# Wrong Part Listed in TM

THE LISTING IN TM 11-1520-237-23P, ITEM 2, PAGE 34-1 FOR CONTROL INDICATOR, NSN 5895-00-138-9213, PN SMD535629, IS **WRONG**.

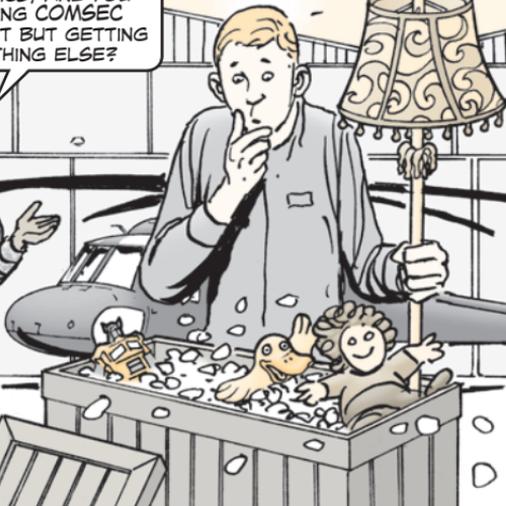
THE CONTROL INDICATOR SHOWN AS FIG 1 IN TM 11-5895-555-23P IS USED ONLY ON THE UH-1 AIRCRAFT, NOT THE BLACK HAWK.

IT SHOULD BE THE REMOTE CONTROL UNIT, NSN 6625-01-026-9623, PN ON241740-1.

MAKE A NOTE IN THE TM UNTIL THE NEXT CHANGE IS PRINTED.
